PRODUCT CHANGE NOTICE
PCN Form (D4-E000-73)**PCN#11-011****NOTIFICATION DATE: August 4, 2011****MODEL(S) AFFECTED:**

ZFSC-8-1+, ZFSC-8-1-75, ZFSC-8-1-75+, ZFSC-8-1-S, ZFSC-8-1-S+, ZFSC-8-4,
ZFSC-8-4+, ZFSC-8-4-75, ZFSC-8-4-75+, ZFSC-8-4-S+, ZFSC-8-43+, ZFSC-8-43-S+,
ZFSC-8375, ZFSC-84-75+

Attachment to **PCN#11-011**

OLD - CASE STYLE DRAWING: R29 (Rev. C)

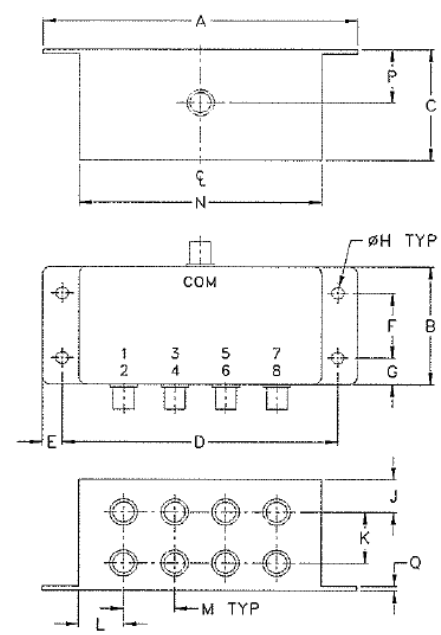
R29 case style: Dimension C increased from 1.50" (38.10mm) to 1.57" (39.88mm)
Dimension J increased from .40" (10.16mm) to .43" (10.92mm)
Dimension P increased from .72" (18.29mm) to .79" (20.06mm)
Dimension Q increased from .062" (1.53mm) to .13" (3.18mm)

Total height increase by .070" (1.78mm)
Connectors standing increase by .040" (1.02mm)
